**Town of Kittery
 Planning Board Meeting
 April 14, 2016**

93 Picott Road – Right of Way Plan Review

**KITTERY PLANNING BOARD
FINDINGS OF FACT -
for
93 Picott Road
Right-of-Way Plan**

PLAN OF PROPOSED
PRIVATE RIGHT OF WAY
FOR
GRAYSTONE BUILDERS, INC.
93 PICOTT ROAD
KITTERY, MAINE

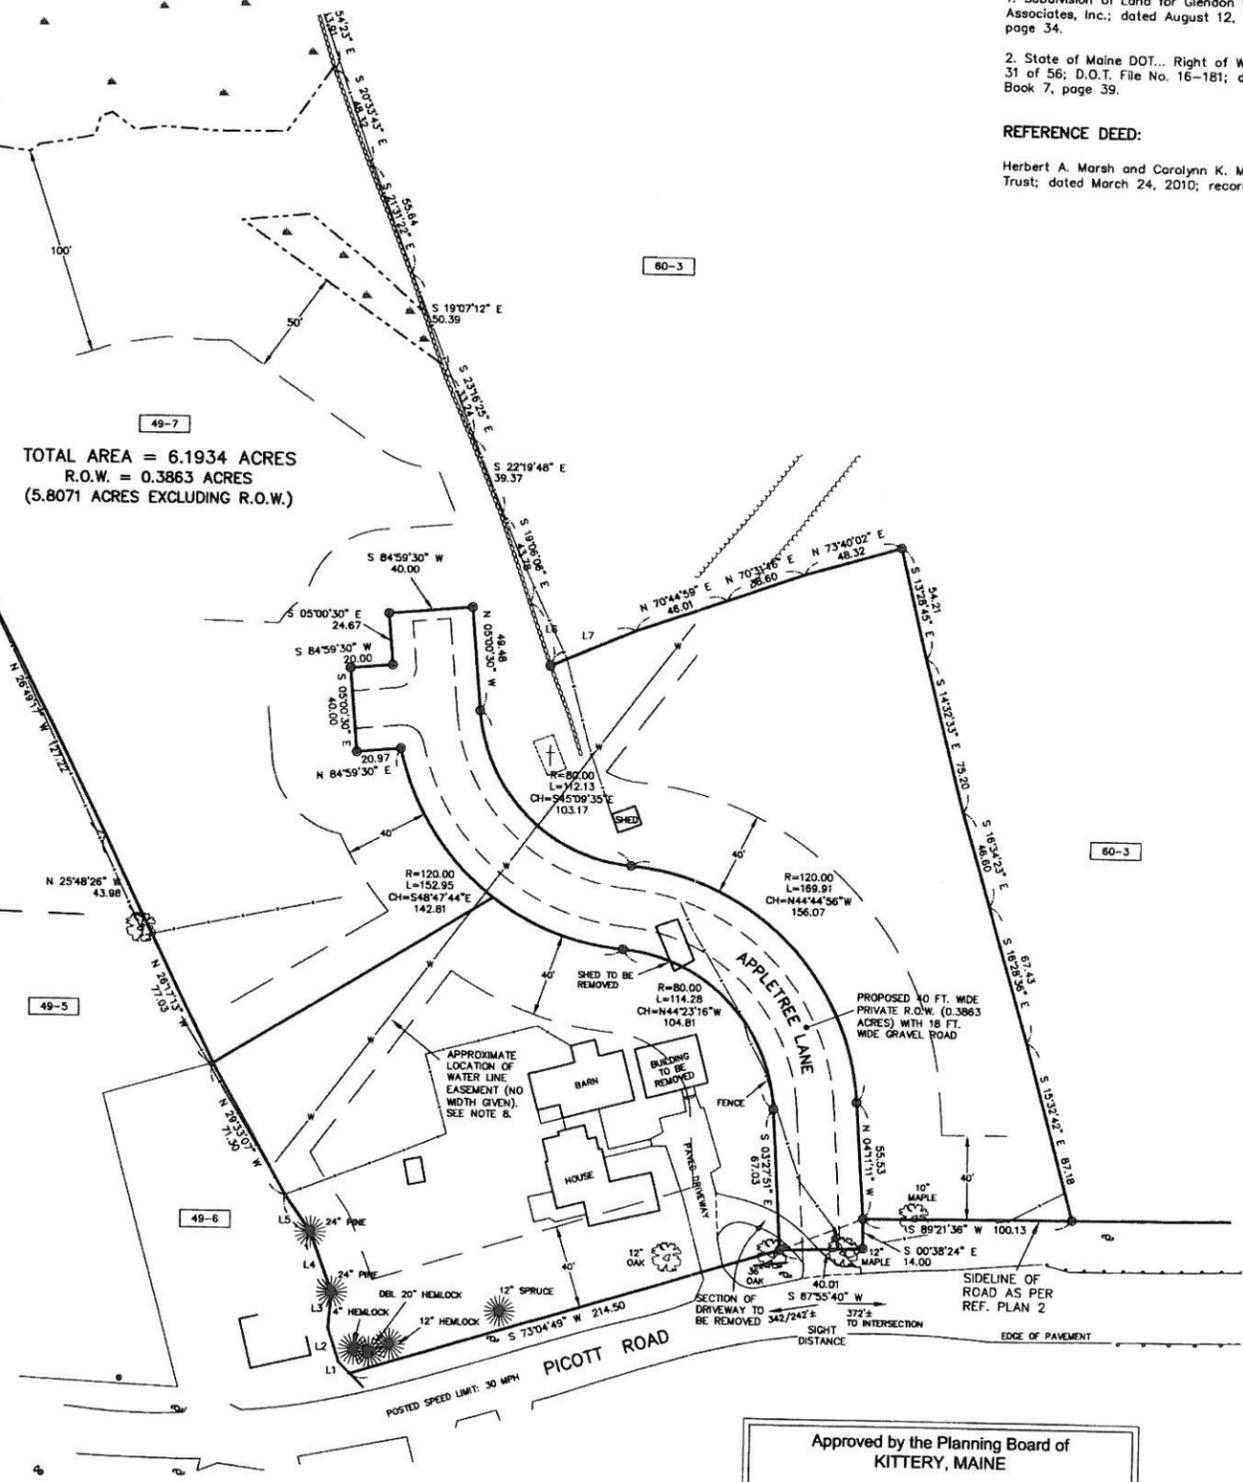
4. The proposed ROW would alter the classification of the existing dwelling to a corner lot condition per the 16.2.2 definition of Corner Lot. With the ROW as shown, the dwelling would be subject to the following:

- a. The side yard, determined as the yard located between the principal building and the side street, may not be less than the front yard requirements. The minimum front yard in the R-RL zone is 40 feet. The proposed ROW creates a side yard of 23-feet and does not conform to zone standards. **UPDATE: The applicant has agreed to remove an existing building that would have prevented conformance with the Corner Lot front/side yard setback requirement. All proposed front and side yard setbacks are in conformance with zone standards. The applicant has submitted a revised plan to show all front and side yard setbacks to the proposed ROW.**

5. The plan depicts a cemetery on the lot, which requires a 25-foot setback for the ROW. The proposed ROW is 22-feet from the edge of the cemetery as depicted and may not conform to State statute. The applicant needs to confirm the bounds of the cemetery per Title 16.2.2 definition and clarify on the plan that there must not be any disturbance within 25-feet of the existing cemetery per MRS 13 § 1371-A.

8. Per Title 16.8.4.3.I, the proposed ROW cannot be accepted by the Town as a public street.
9. The graphic scale on the plan depicts 1 inch = 50 feet. However the actual scale the plan is plotted at is 1 inch = 40 feet. **UPDATE: Revised plans continue to depict 1 inch = 50 feet. Final plans will need to show the actual scale of 1 inch = 40 feet.**

1. Update the plan with the following revisions.
 - a. Depict proposed front yard setbacks for ROW
 - b. Depict front, side and rear yard setbacks for the existing dwelling and parcel.
 - c. Update graphic scale
2. Revise the proposed ROW so it conforms the dimensional standards of the R-RL zone with consideration of the corner lot as defined in Title 16.2.2.
3. Revise the proposed ROW so it conforms with setback requirements in regard to the cemetery, or provide plan note suggested in staff note #5.
4. Submit CMA review fee to Town.
5. Submit a Street Naming Application to Town – **Applicant stated a Street Naming application was submitted when meeting with the Town Assessor to obtain Map and Lot IDs for the proposed**

BOUNDARY SURVEY
PREPARED FOR
GRAYSTONE BUILDERS, INC.
93 PICOTT ROAD
KITTERY, MAINE

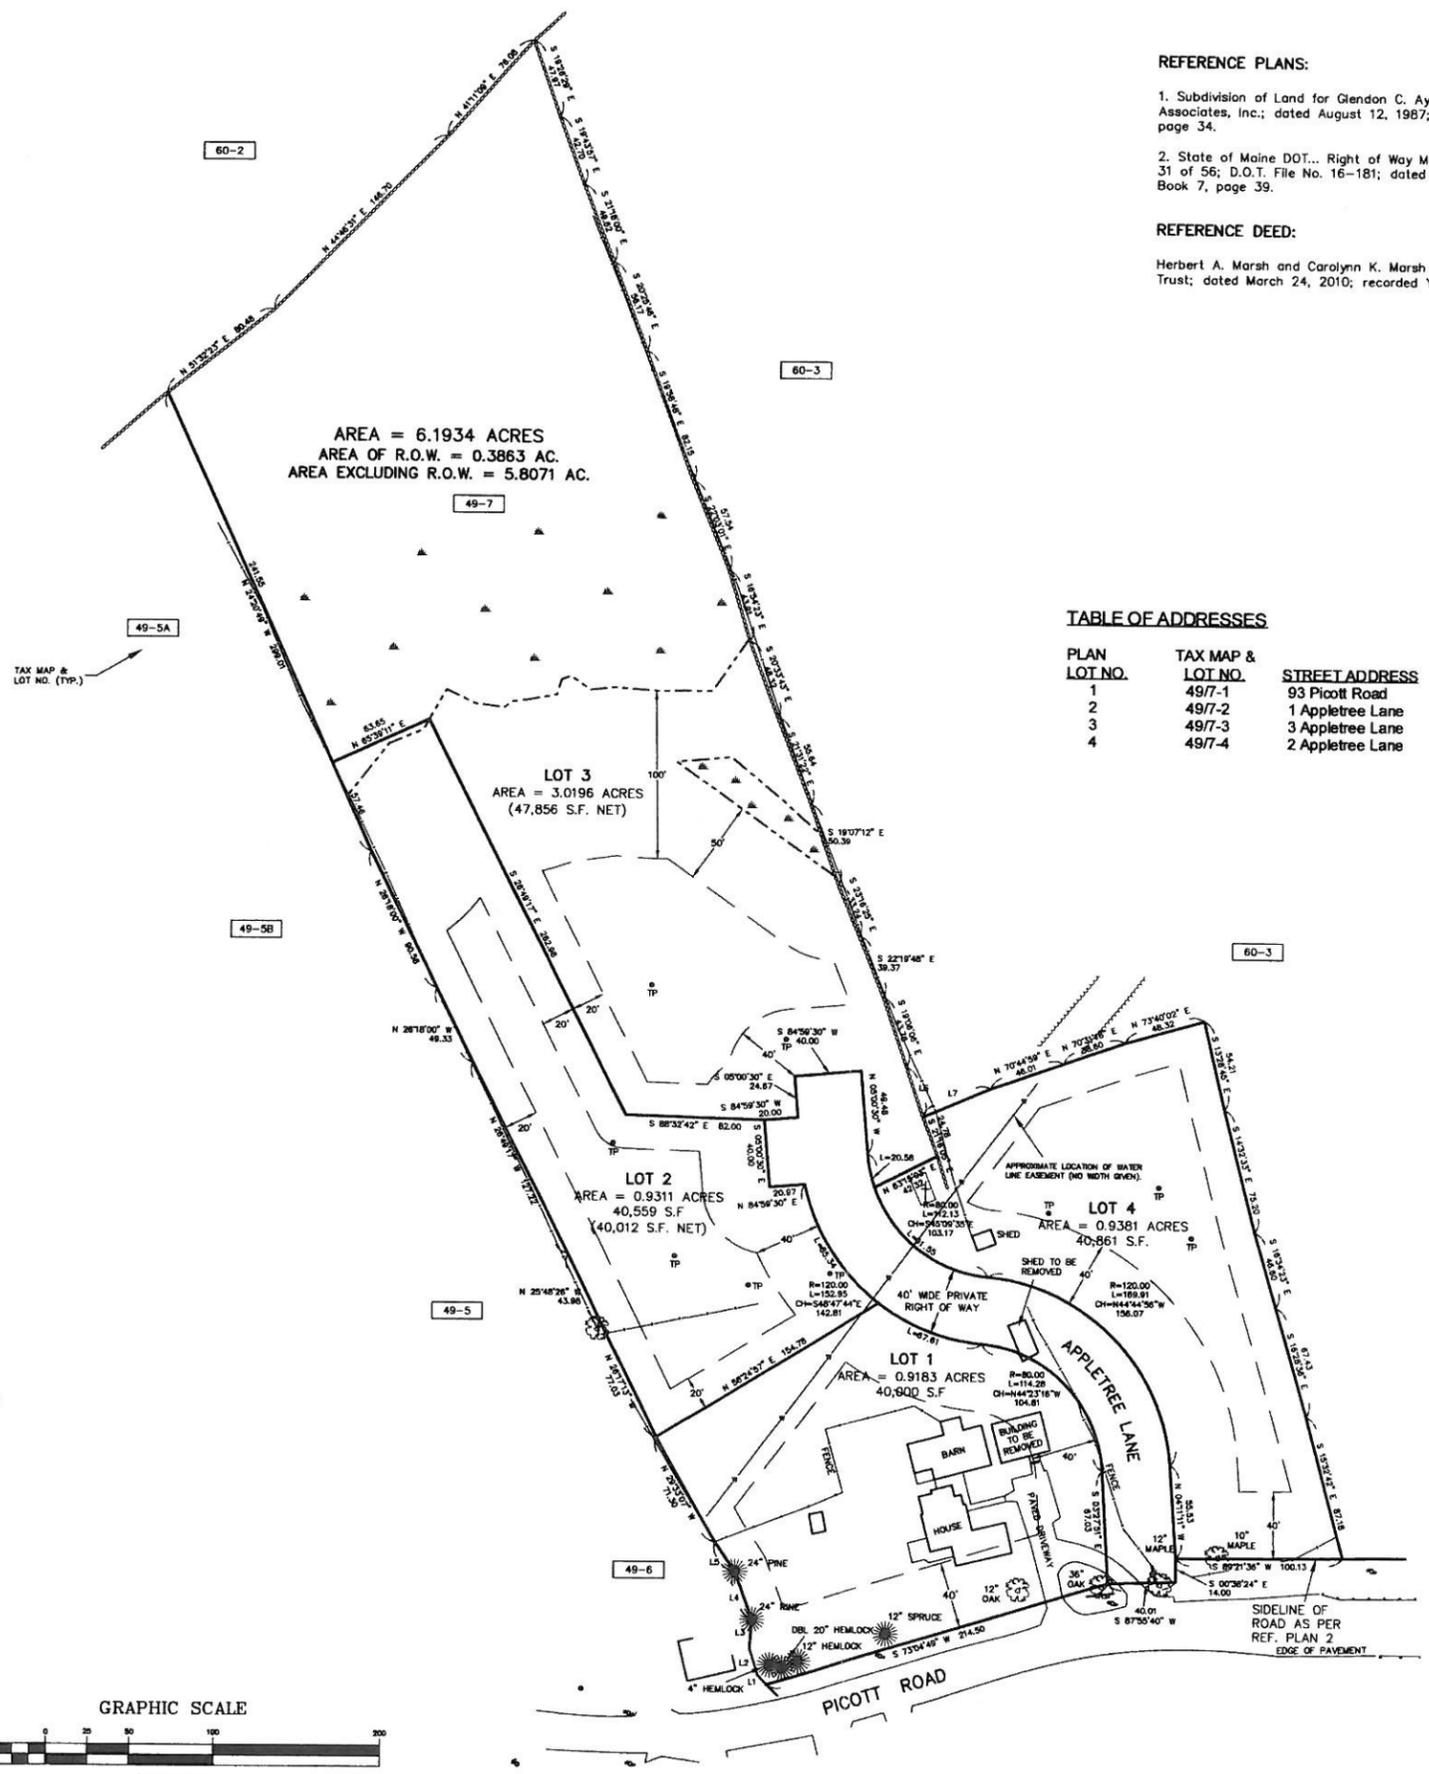
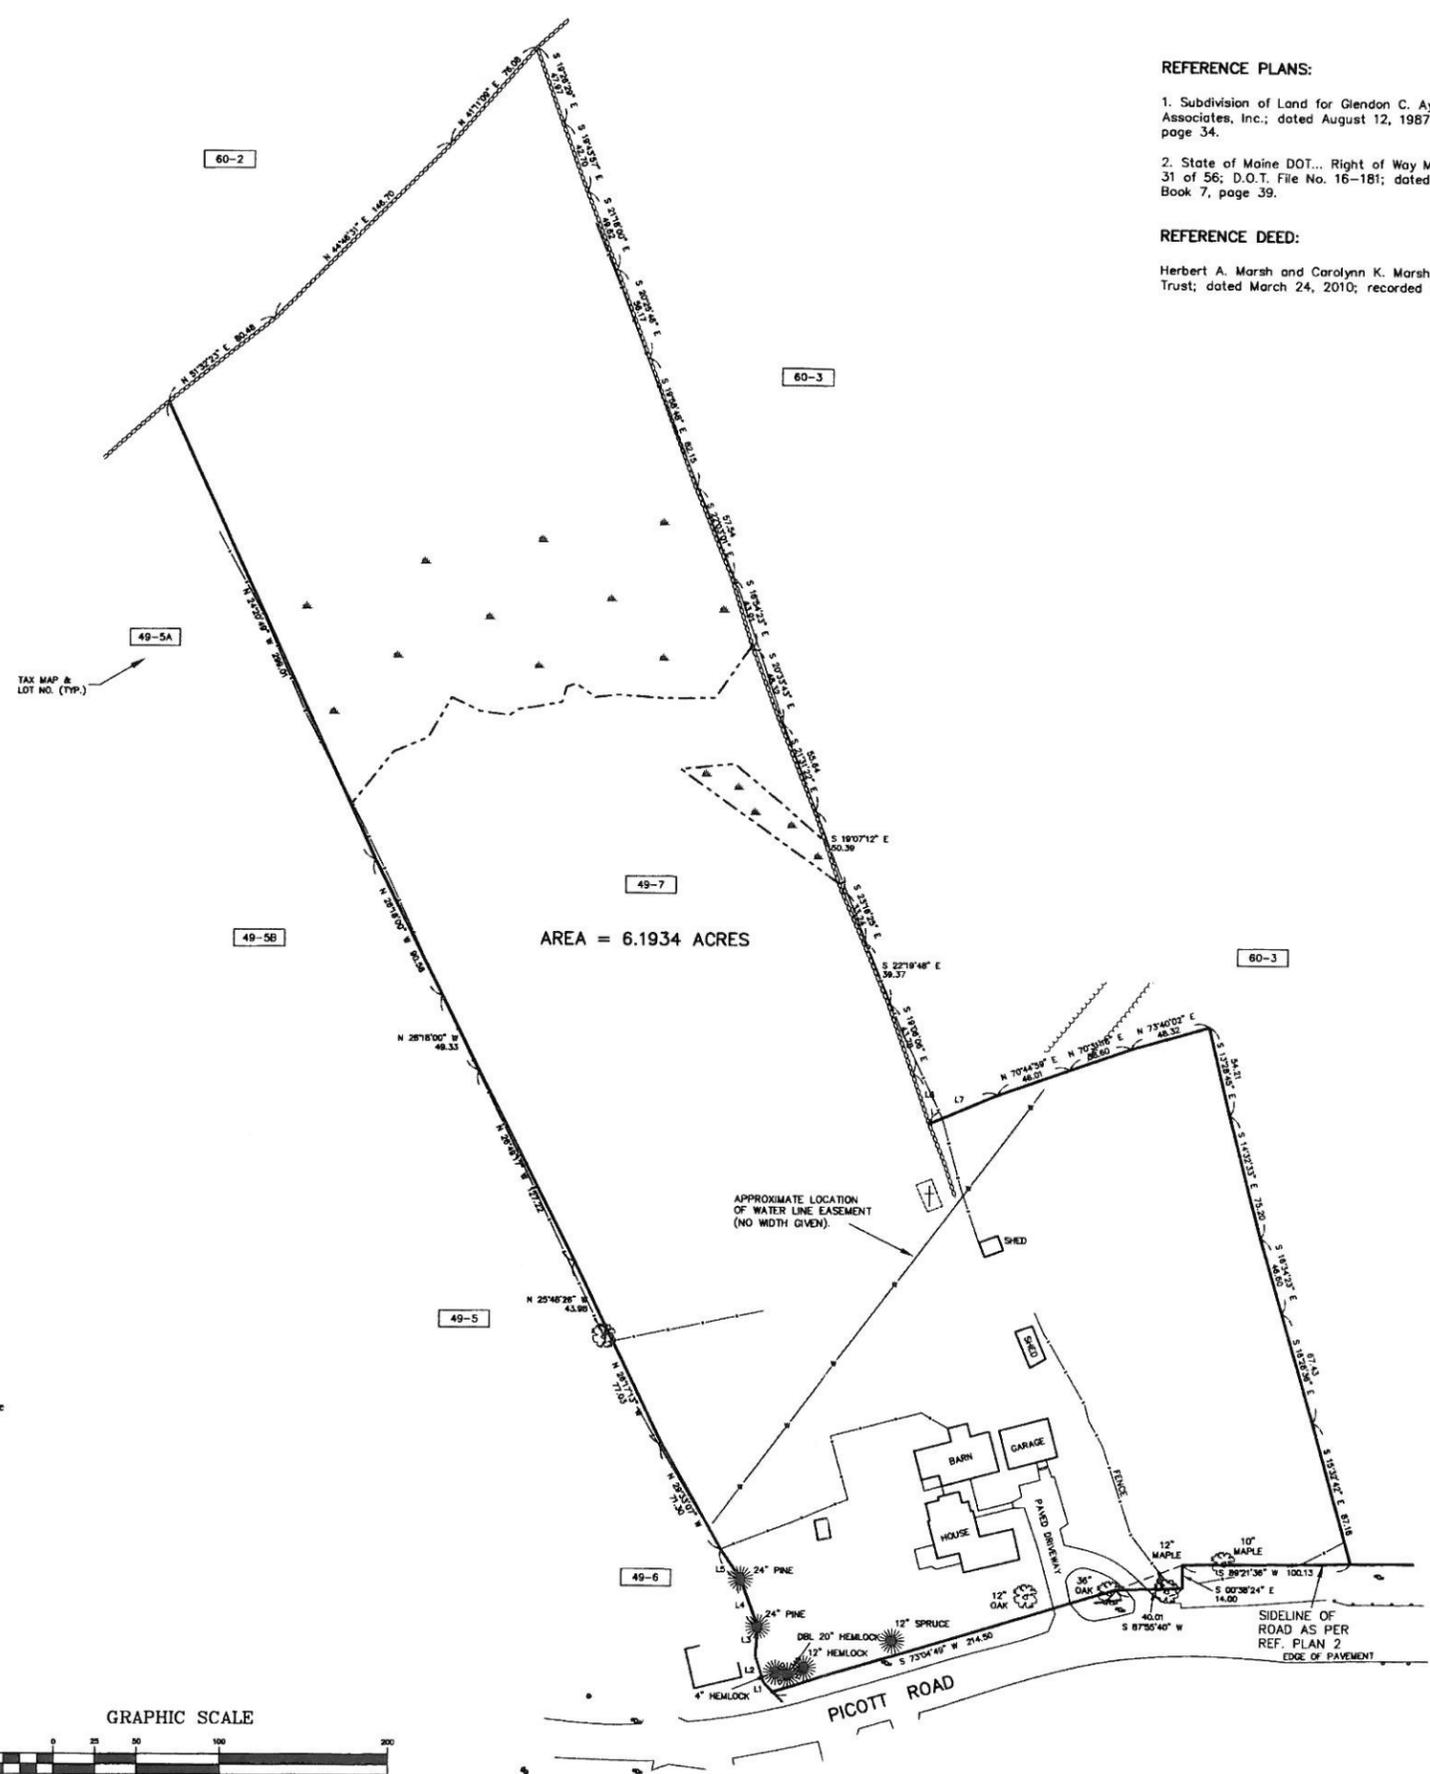
7. Prepare and submit a standard boundary survey. The applicant has submitted one, however, the plan note #1 appears not to support any definitive identification of ownership which presumably is necessary for demonstrating right, title and interest, and ultimately land conveyance.
